Access Compliance Report

Public Rights-of-Way

(Pedestrian Signals)

Intersection ID: N/A	Main Street:	Cross Street: N/A	Location: N/A
ADA ID: DEFA27433A1B	Signal Type: Two Push Buttons-Non APS	Overall Compliance: No	Severity Score: BTN 1:N/A BTN 2: N/A No BTN: N/A
Codes/Mitigation Info/Possible Solution		Field Measurements/Component Compliance

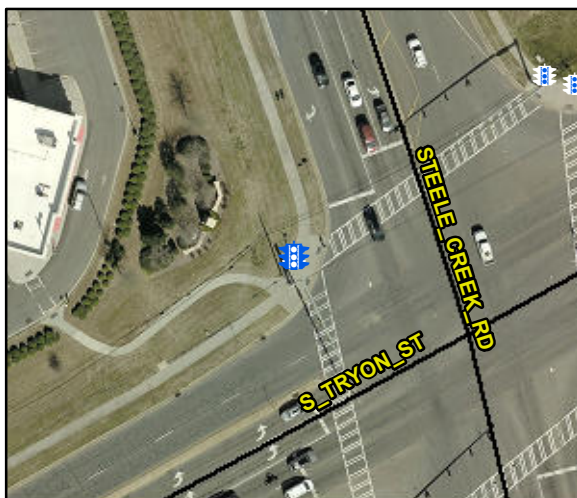
Surveyor Notes: TEXT HT 1/2

PROW/ADA: R410.6, TMUTCD 4e.08, R404.2, R404.3, R406.2

Possible Solutions: Replace Signal Push Button With APS Button on New Post. Remove & Replace Sign.
